# Index 700-120 Enhanced Highway Signing Assemblies

### **COMMENTARY**

#### **COMMENTS AND RESPONSES**

ROADSIDE SIGN ASSEMBLY-9

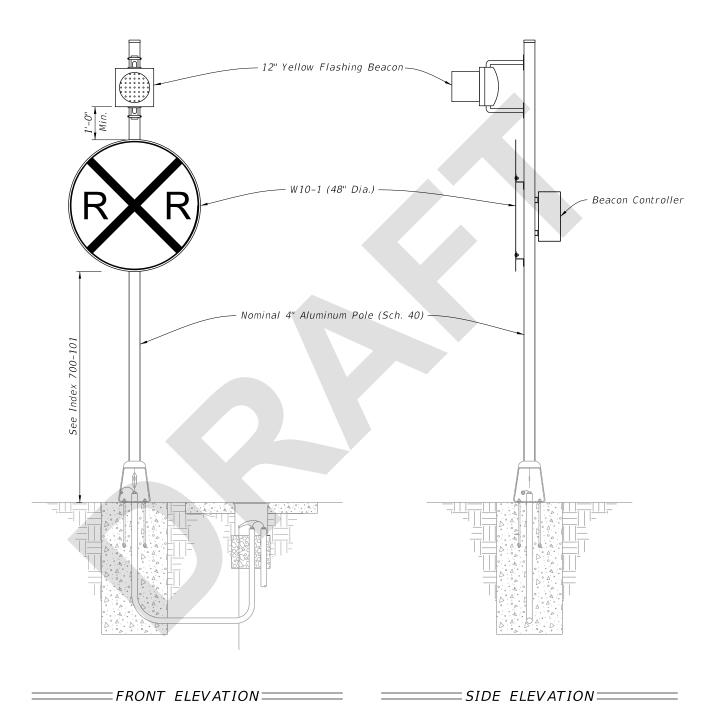
**COMMENT:** New "Roadside Sign Assembly-9" should not have a highlighted W10-1 sign. It should be a standard W10-1 sign with the Yellow Flashing Beacon. No need to combine a highlighted sign with a beacon.

**RESPONSE:** Agree. We will remove the highlighted part from the index.

**CHANGE MADE TO INDEX:** Yes.
